Addendum 01

DOCUMENT 00 9100

PROJECT: Cedar Cliff Schools Connector Addition and Renovation
194 Walnut St
Cedarville, Ohio 45314

PROJECT #: 25056.00

SHEET NUMBER:
A6.1

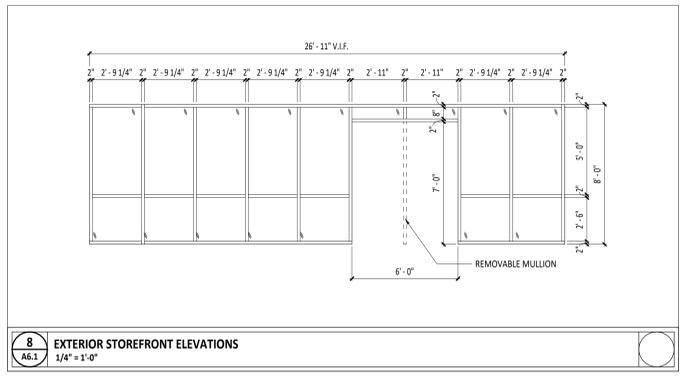
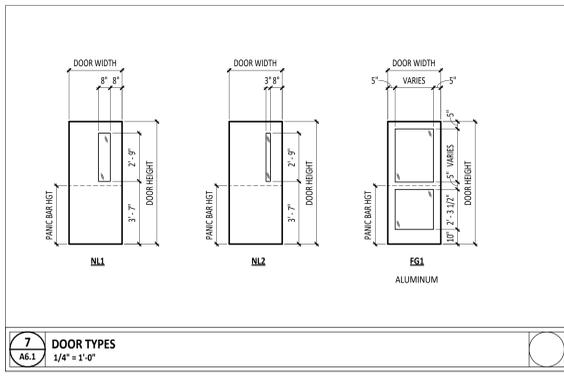
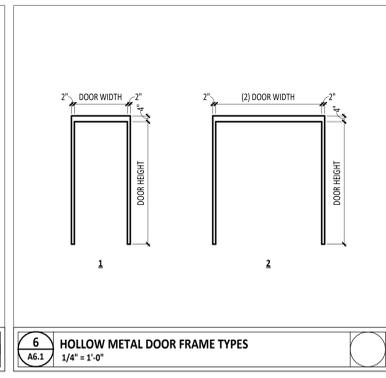
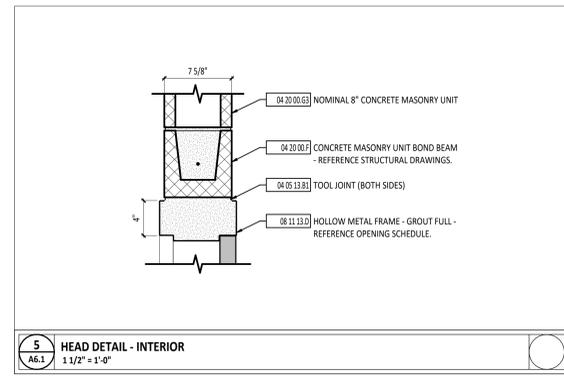
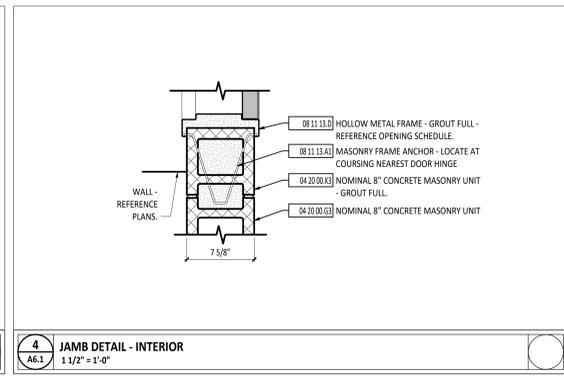
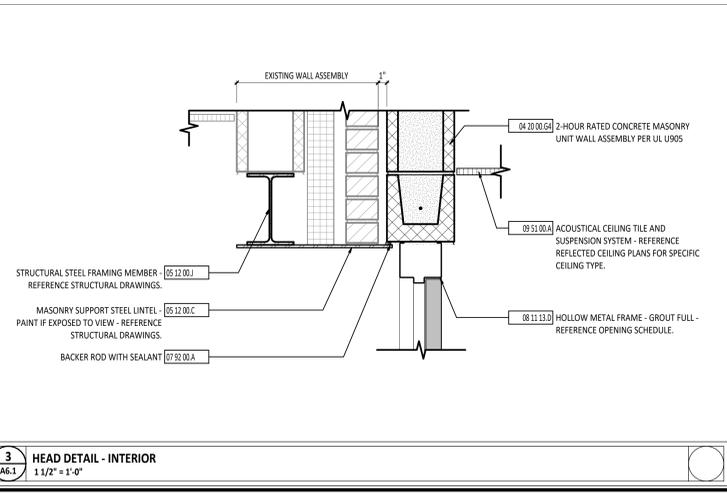
- a. Clarified that note 6 in the door schedule is to be owner provided, contractor installed vinyl emergency numbering. Added the corresponding note to the appropriate doors in the schedule.

2 FIRST FLOOR MECHANICAL PLAN - UNIT A
1/8" = 1'-0"

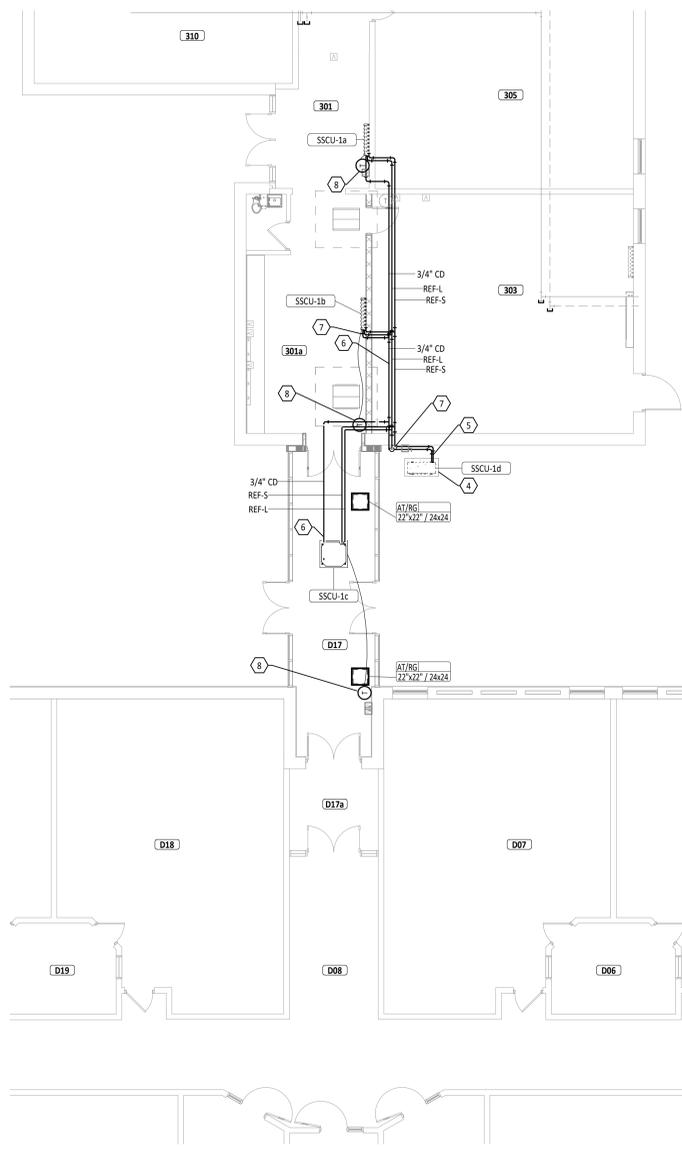
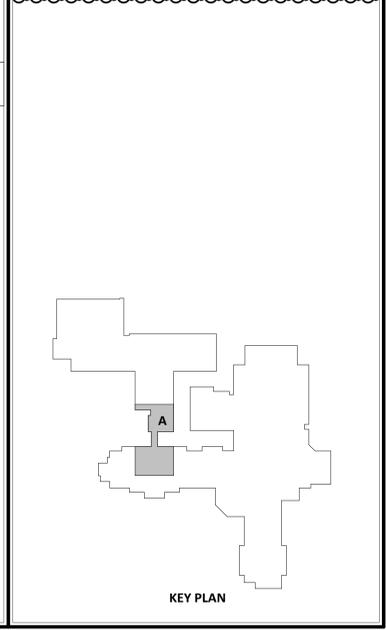
5. Drawing Sheet M2.1 – First Floor Mechanical Plan – Unit A
 - a. Deleted control the units through the building automation system from keynote #8.
